Quality Control Check Report. Stage: After Finishing Stage III (Apartments)

Flat No	A-904	Other	SI. No.	38471
Company	MPL	Project	Phase	-
Prepared by	T.Vinod Kumar	Sign	Date	29-09-21
Project Manager	Subba Reddy	Sign	Date	29-09-21
Previous stage report no.	37800	Report filed and signed by PM	☒ Yes ☐ No	
Checked By MD on	MD Sign	For filling	☐ Yes ☐ No

MAYFLOWER PLATINUM

Details of Additions & Alterations

ELECTRICAL PLAN OF FLAT-A4

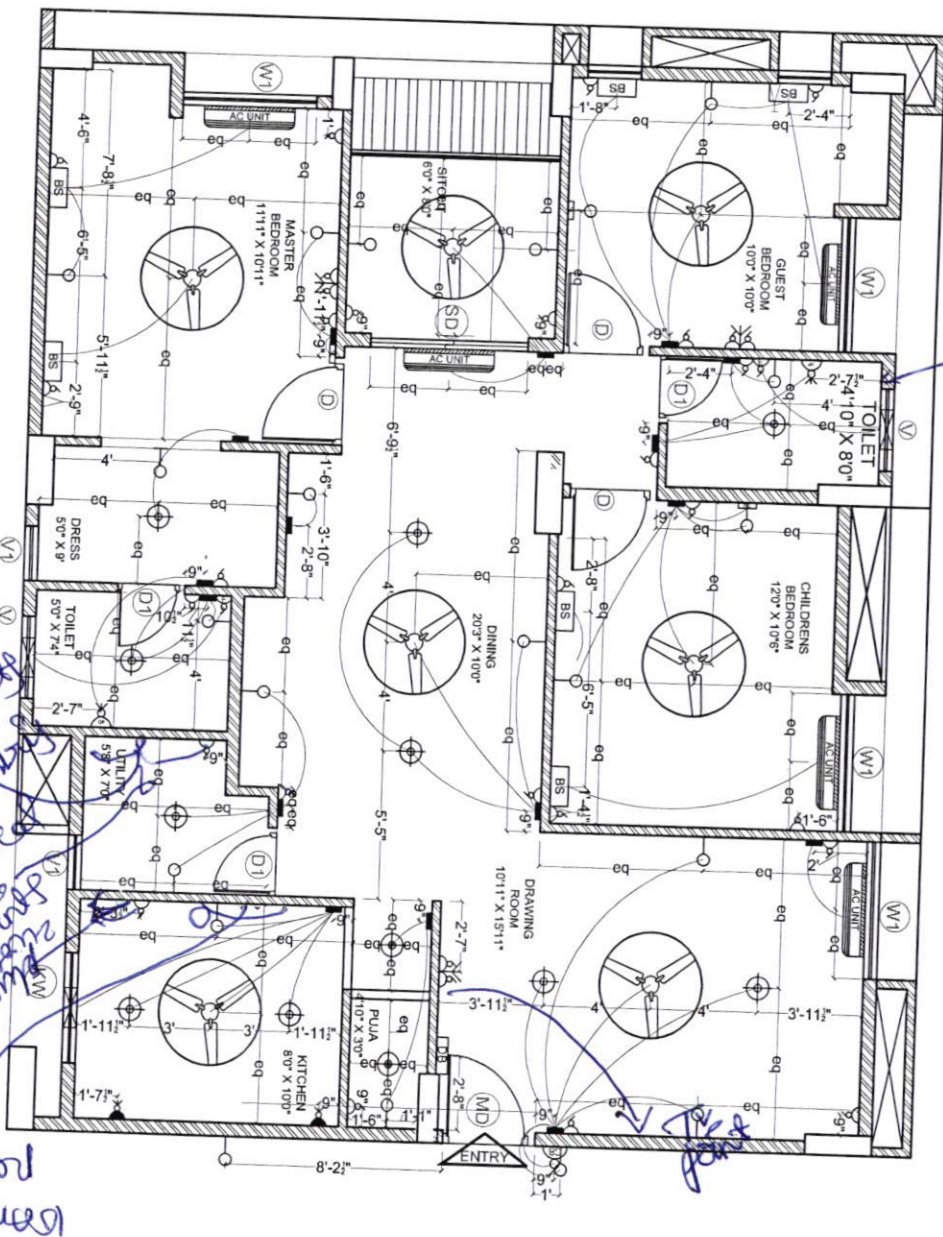
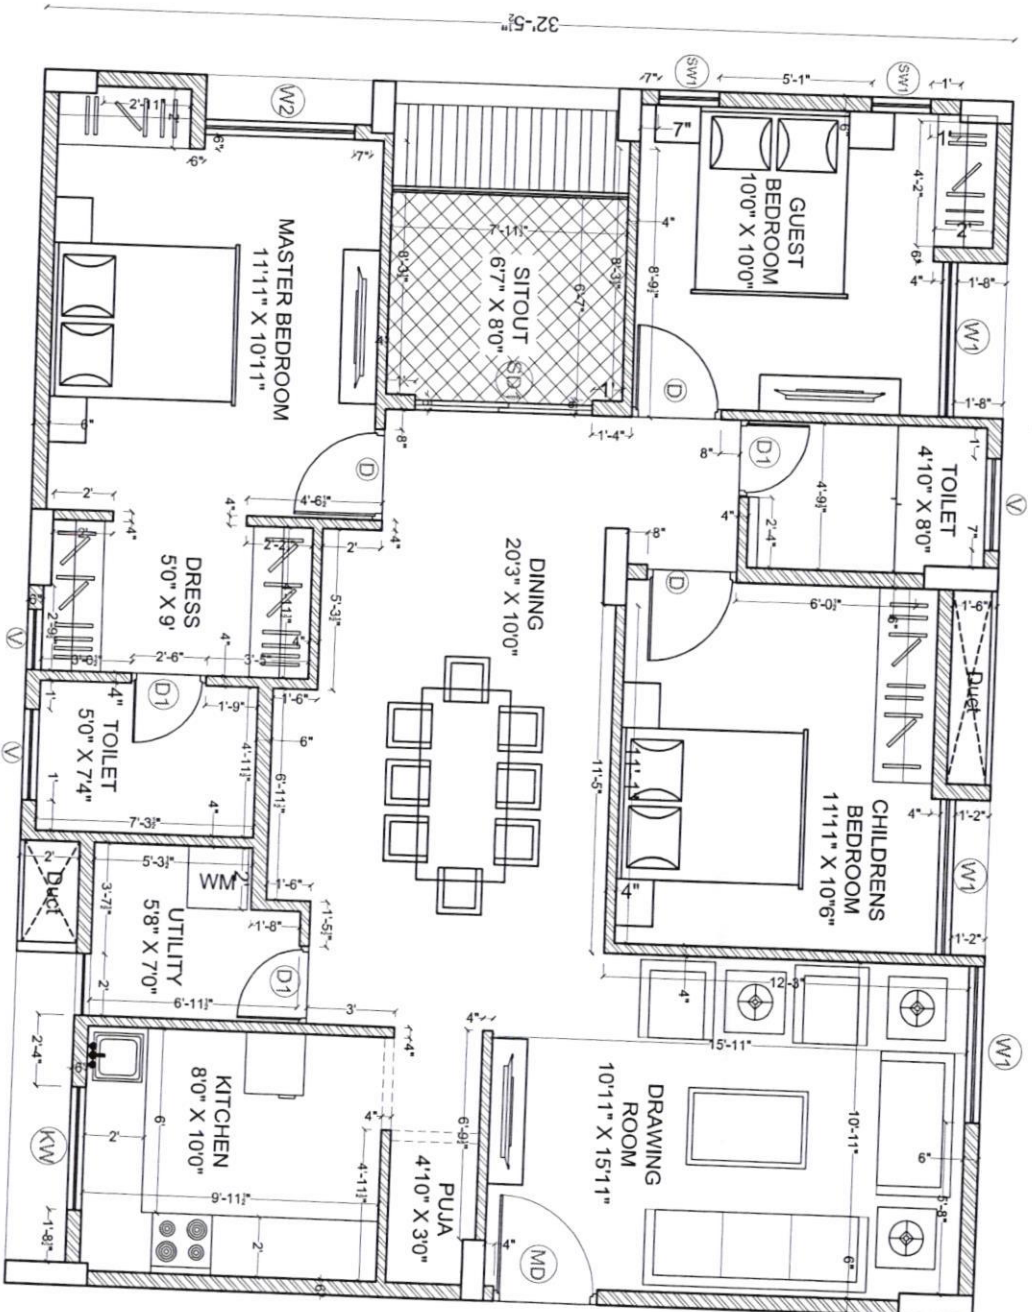
Changes in electrical points: (mark on plan)

- 1) Electrical point extra at kitchen entrance wall
- 2) Exhaust holes & fan provision given by two bathrooms
- 3) Above washbasin light point at dining wall.

WORKING DRAWING OF FLAT.NO. A-4

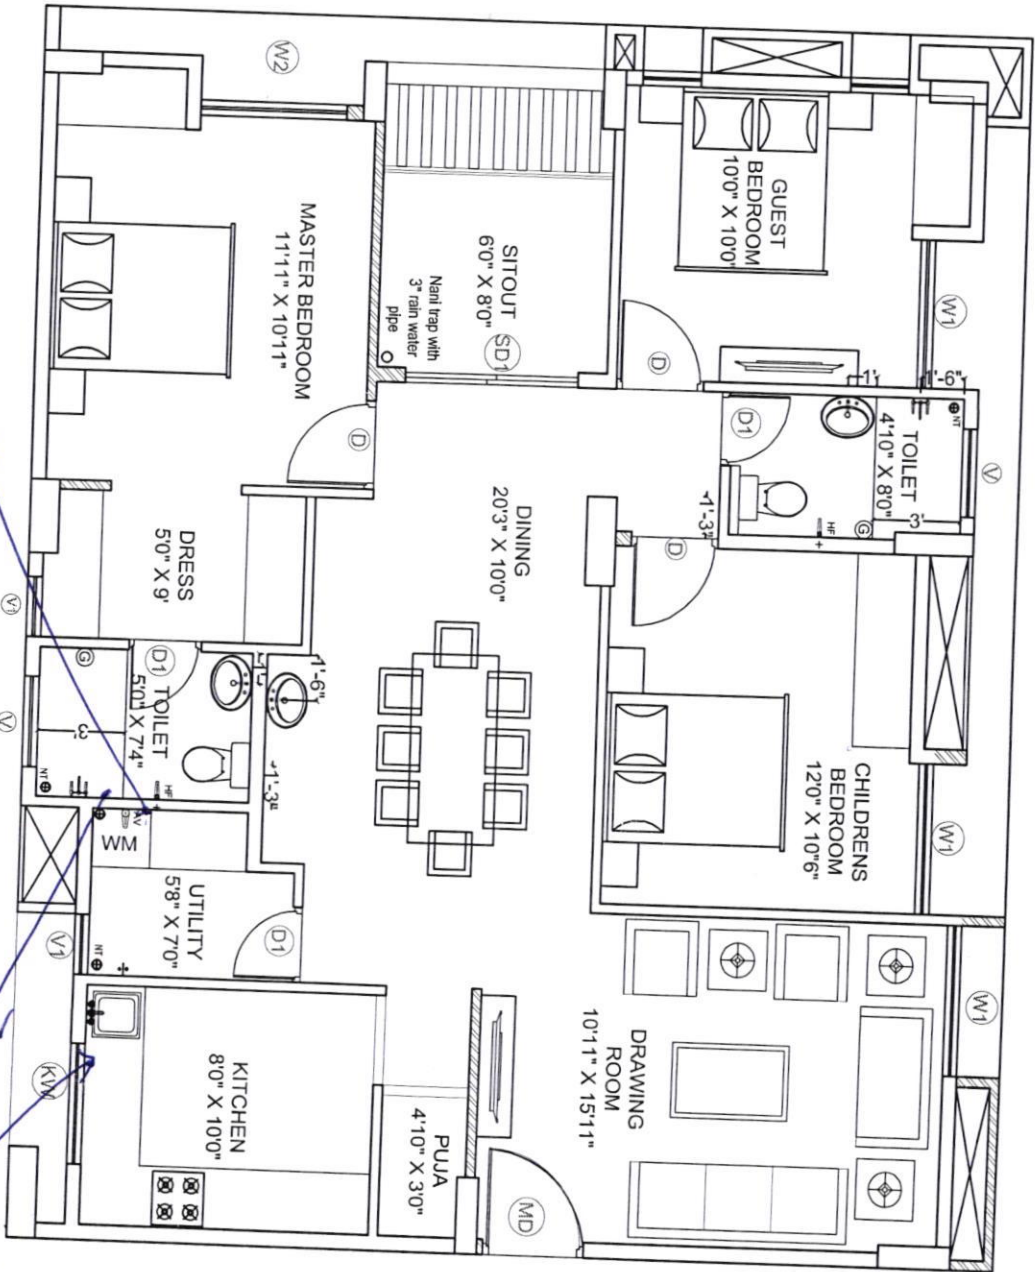
Changes in kitchen platform: (mark on plan)

- 1) kitchen platform ~~2 shape~~ same as model flat
- 2) ~~sink point changes~~ marked in plan.

→ No modular kitchen,
do not assemble.
